International Isotopes Inc.

Subject: Request to Amend NR-1235-S-102-S.

International Isotopes Inc. requests to amend Registry of Sealed Sources and Devices Safety Evaluation of Sealed Source Number NR-1235-S-102-S to include a source geometry that replicates that of a syringe. International Isotopes Inc. considers the syringe geometry as an improvement over the standard 30 ml vial source geometry which is commonly utilized by many nuclear medicine facilities to calibrate instruments used to comply with § 35.63 *Determination of dosage of unsealed byproduct material for medical use* of Title 10 of the Code of Federal Regulations. As with the current BM06 Model, International Isotopes Inc. is the contracted manufacturing for the source which is distributed under the Bench/mark by RadQual label. Both companies are committed to provide the nuclear medicine industry with a calibration source geometry that closely resembles the actual dosage geometry. The companies have contracted with the United States National Institute of Standards and Technology to develop a NIST traceable standard for the syringe geometry.

The current NR-1235-S-102-S describes the Model BM06 series source. Intern

Source Label Example

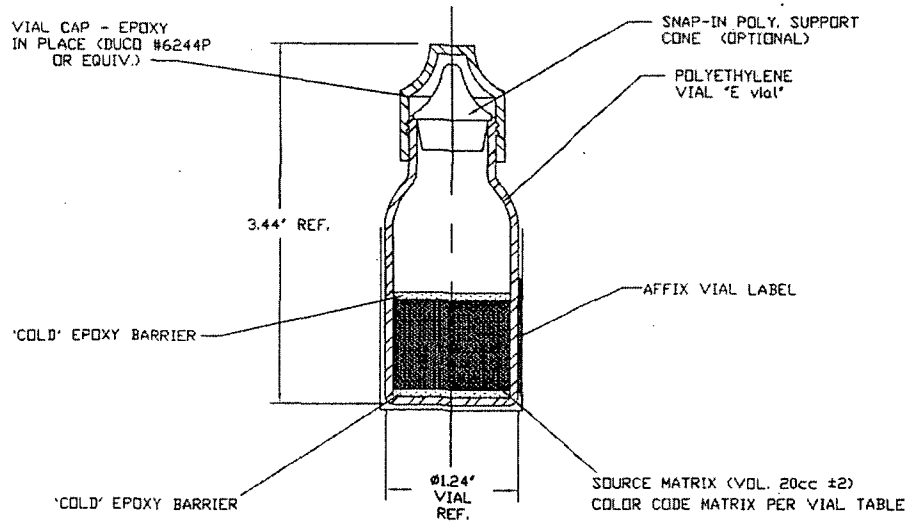
Page 3, LABELING: Revise the labeling paragraph to read:

“Each source and storage pig is conspicuously labeled with the source isotope and activity and bears the warning “Caution: Radioactive Material” as well as the trefoil radiation symbol in magenta on a yellow background, the designer’s name, and the name of the manufacturer. Each label also contains the source model number, serial number and a reference date for the source activity. The label will be affixed to the exterior of the source and will be laminated so that the label remains legible and is not degraded as a result of normal use. Refer to Attachment 1”.

A new source label is provided for use in Attachment 1.

MODEL BM06S

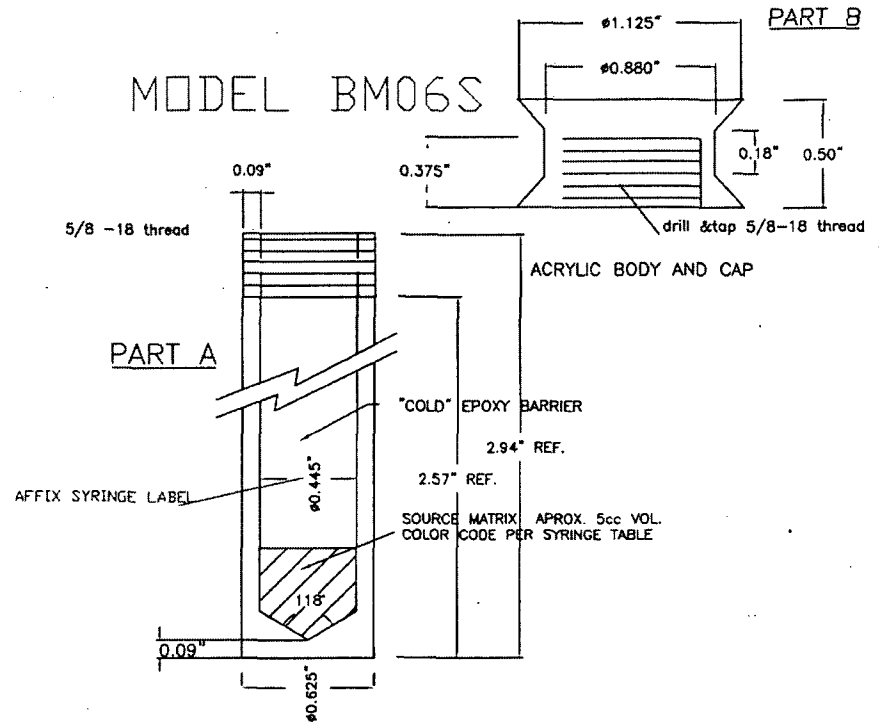
“The Model BM06 Series are intended for use as reference standards to check the response of dose calibrators used to measure research, diagnostic, and therapeutic radiopharmaceuticals. The BM06 Series offers these reference standards in two differing geometries. The first of these is the 30 ml Vial Geometry referred to the BM06E. The second geometry is the 5 cc Syringe Geometry referred to as the BM06S. Both the BM06E and S Series consists of a radioisotope in a chloride or nitrate complex uniformly dispersed in high impact epoxy casting resin (Emerson & Cuming Stycast 1264 or equivalent) color coded to visually differentiate the radioisotopes, which is then cured in either a 30 ml dose calibrator vial or a facsimile a 5 cc syringe. The BM06E epoxy containing the dispersed radioactivity is sandwiched between two layers of epoxy which does not contain radioactive material. A rubber septum or equivalent material is chemically welded into the neck of the vial and a color coded (to visually differentiate the radioisotopes) screw top cap is chemically welded onto the vial so that disassembly without destruction of the vial is not possible. The syringe geometry consists of a body and cap manufactured with a translucent acrylic. The body is filled with a layer of epoxy containing dispersed radioactivity which is sealed beneath a layer of epoxy containing no radioactive material. A screw type acrylic cap, color coded to match the epoxy matrix is chemically welded into the body of the syringe so that disassembly without destruction of the syringe is not possible. Refer to the drawing provided in Attachment 2. Each source is supplied to the customer in a shielded storage pig”.

As you will note that the source matrix in the syringe geometry is not “sandwiched” between two layers of cold epoxy. The reason for this is that the bottom of the “syringe body” has a slight taper to better simulate the taper found at the bottom of an actual syringe, filling this taper with inactive epoxy would negate this design feature.

The Model BM06E is approximately 1.25 inches in diameter and 3.5 inches in height. The Model BM06S is approximately 0.625 inches in diameter and 2.94 inches in height”.

Additional detail regarding the dimensions and the materials of these geometries is provided in the attached drawing.

An updated drawing is provided for use in Attachment 2.
